X3T9.2/87-133

TO: John Lohmeyer, Chairman X3T9.2
FROM: Gerald Marazas, IBM Corporation
SUBJECT: Proposal for High Density Shielded SCSI-2 Connector

Proposed Extension of Section D2.

FIGURE D5. SHIELDED SCSI CABLE CONNECTOR, ALTERNATIVE 3.

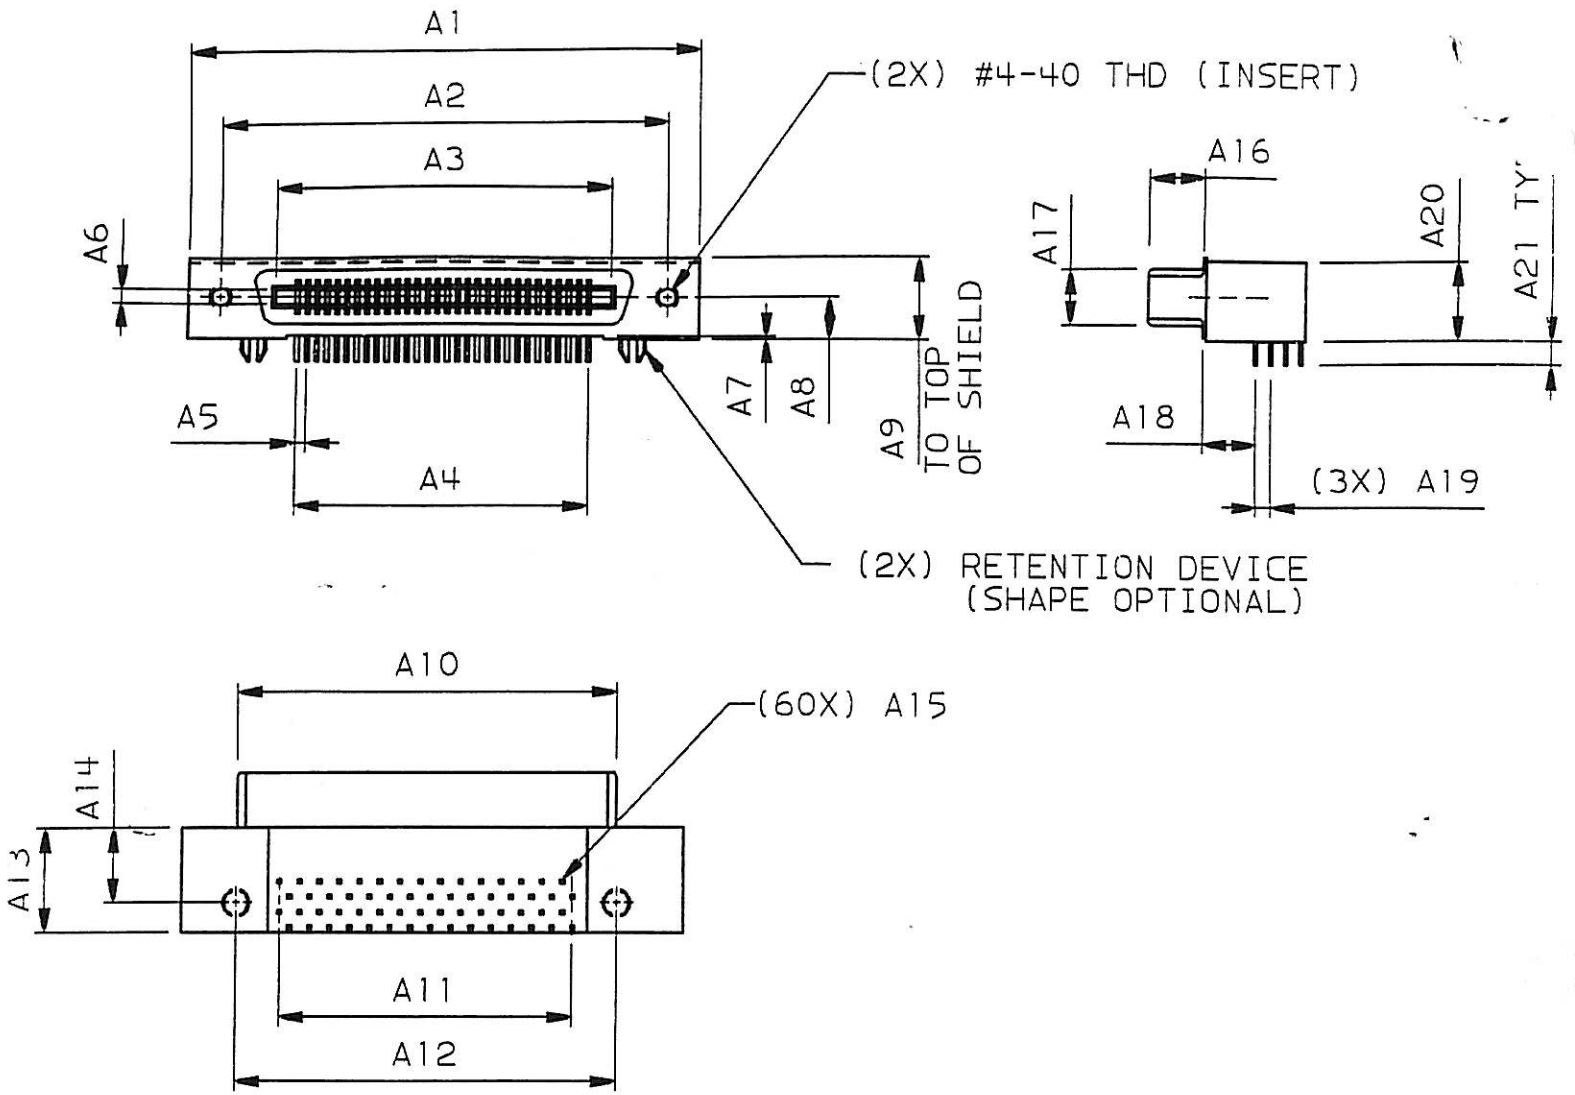
The shielded device connector (Figure D5) is a 60-conductor connector consisting of two rows of ribbon contacts spaced 1.27 mm (0.05 inch) apart. Connector pin assignments for conductors 1 through 50 are shown in table D1 for single-ended drivers and are shown in table D2 for differential drivers. Conductors 51 through 60 are vendor unique.

Electrical continuity is to be maintained for all 60 conductors. Adaption between 60 wire originators and a 50 wire device will be accomplished either within the confines of the cable or within the unit box holding the 50 wire device.
